IRPS5401 Errata Final Silicon

PSS DCDC Enterprise Power
January 2021

IRPS5401 Errata Final Si --Summary

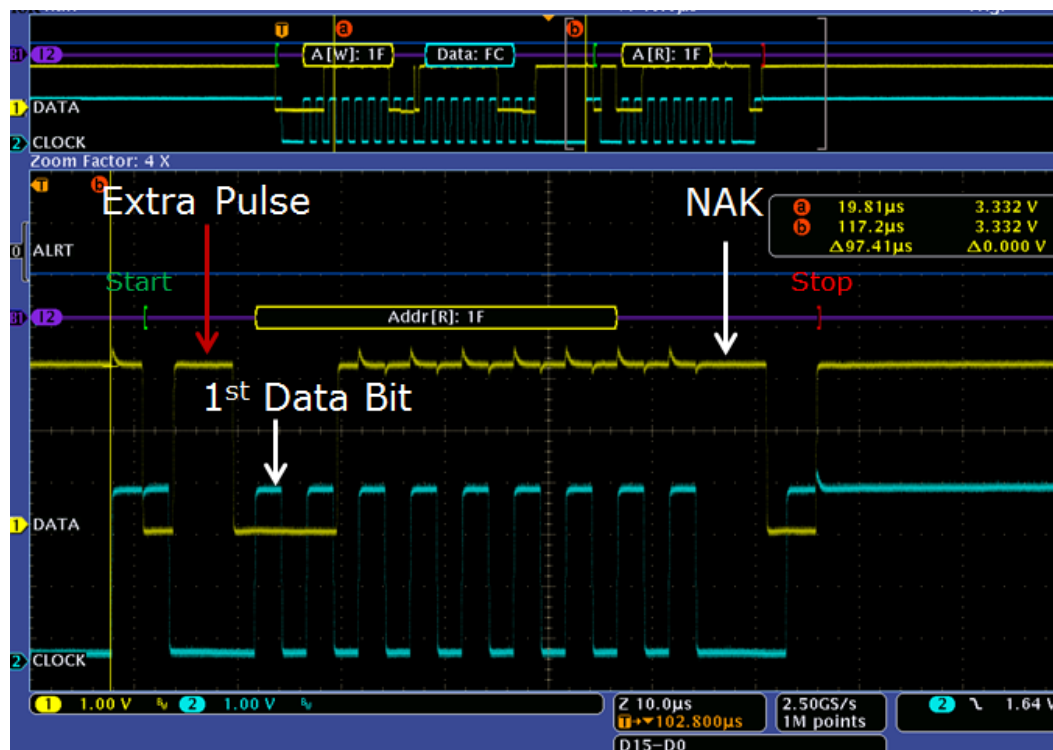
Item	Errata Description			
1	Errata	During Power On Reset (POR), the last 24 bits of data stored in NVM are not restored correctly to the working registers. These 24 bits affect PMBus commands related to the LDO output		
		LDO PMBus command bits not restored correctly	Data Source in NVM	Acceptable Values in Source Registers
		STATUS_INPUT mask [7:5]	VIN_UV_WARN_LIMIT; bits 6 to 8	Set to 0. Since VIN_UV_WARN_LIMIT bits 6 through 9 must be set to 0, the largest value that can be set without causing an issue is 0xC83F → 0.49V.
		STATUS_TEMPERATURE mask[7:6]	POWER_GOOD_ON; bit 0	
			VIN_UV_WARN_LIMIT; bit 9	
		STATUS_CML mask [7:1]	POWER_GOOD_ON; bits 1 to 7	Set bits 1, 5, 6, and 7 to 0. Bits 2, 3 and 4 can be set to 1 because the corresponding CML mask bits are not supported. Bits 8 to 11 can be set to 1 if a PG delay is acceptable. The table below shows allowable values
				VOUT_MODE = -8 (recommended) VOUT_MODE = -9

MFR_TPGDLY[3:0]	POWER_GOOD_ON; bits 8 to 11	0x001C → 0.1V, 0msec PG delay 0x0100 → 1V, 1msec PG delay 0x0200 → 2V, 2msec PG delay 0x0300 → 3V, 3msec PG delay
		MFR_LDO_MARGIN[7:0]	POWER_GOOD_OFF; bits 0 to 3 POWER_GOOD_ON; bits 12 to 15	0x0100 → 0.5V, 1msec PG delay 0x0200 → 1V, 2msec PG delay 0x0300 → 1.5V, 3msec PG delay 0x0400 → 2V, 4msec PG delay
	Issue	NOTE** Affects Source Only mode; POWER_GOOD_ON and OFF commands are irrelevant in Tracking mode...see below		
	Workaround	Configure NVM bits (Source registers) so that the affected registers have acceptable data		
	Corrective Action	None

In Tracking mode, set POWER_GOOD_ON & OFF commands to 0. They are fixed thresholds set by VIN
